Subject: Grand Gulf Nuclear Station  
Docket No. 50-416  
License No. NPF-29  
Response to Generic Letter (GL) 95-07  
Request for Additional Information

GNRO-97/00056

**Response to NRC Request for Additional Information**  
**Generic Letter 95-07**

TEST1 COMPLETE  
6.3.3 PRESSURE LOCK TEST TEST#1 a,b,c.

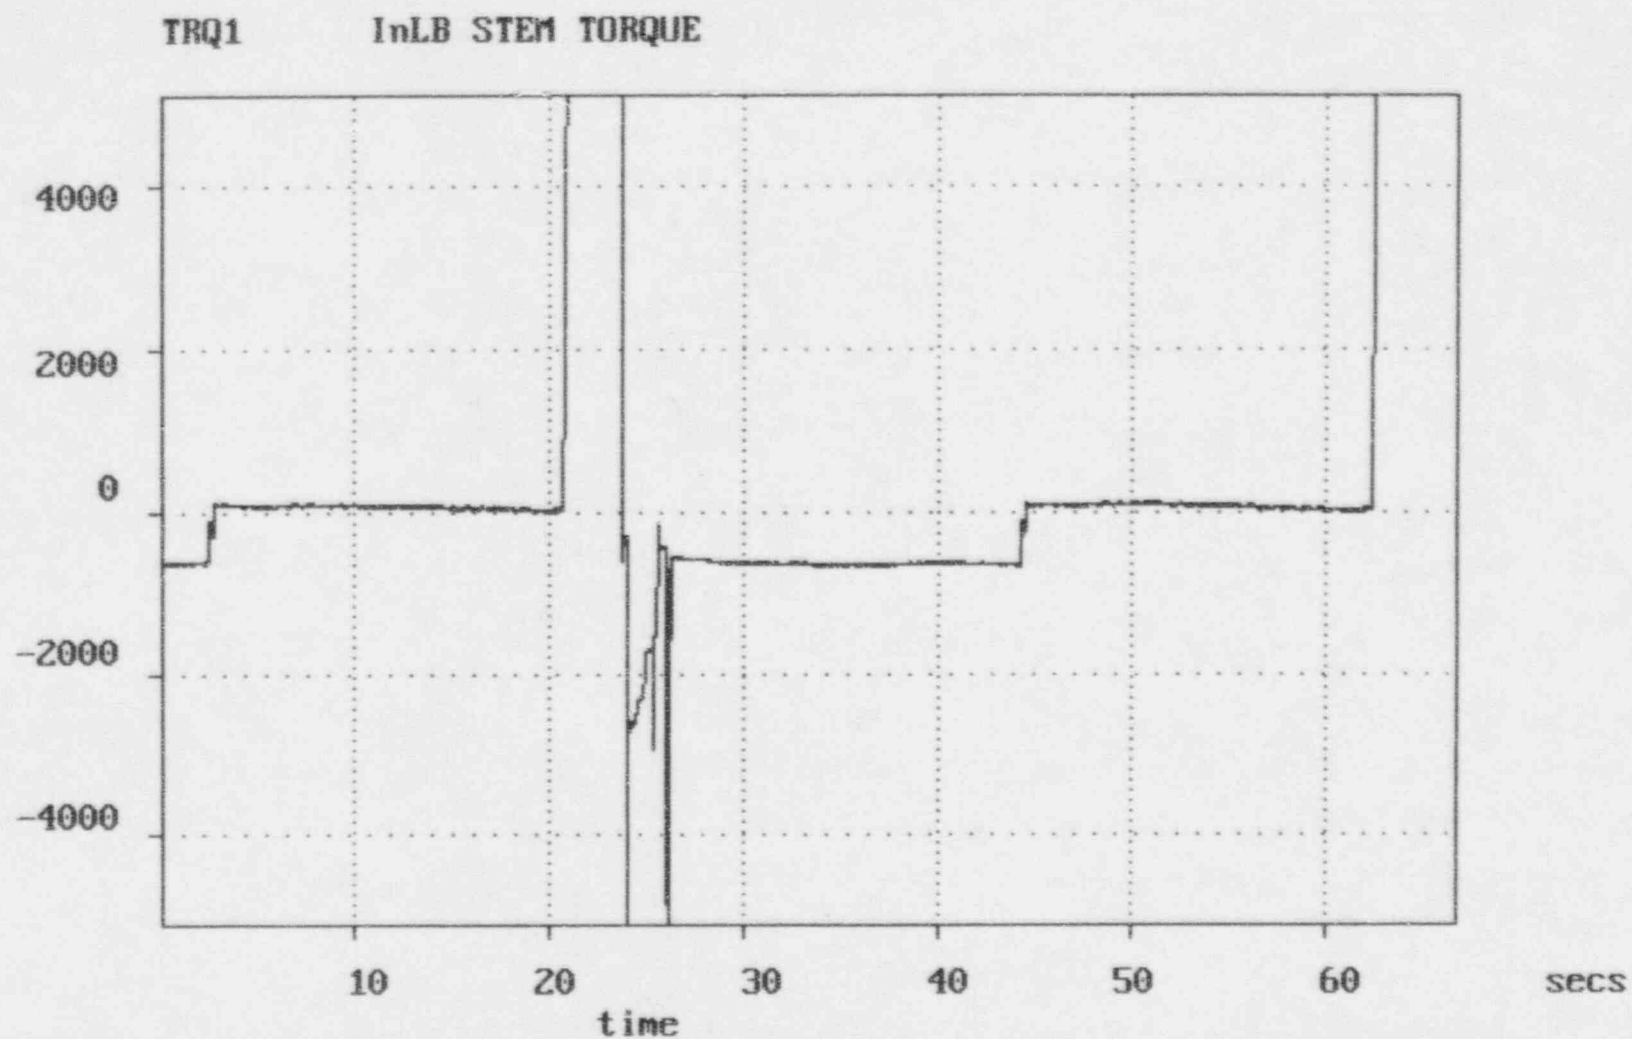
1. "The NRC staff reviewed the test report (14-inch William Powell Gate Valve) but the information necessary to independently verify the pressure locking test results was not in the report. Discuss the schedule when the test data can be provided to the staff."

The test data on the 14 inch William Powell gate valve is provided as Appendix 1 to this package.
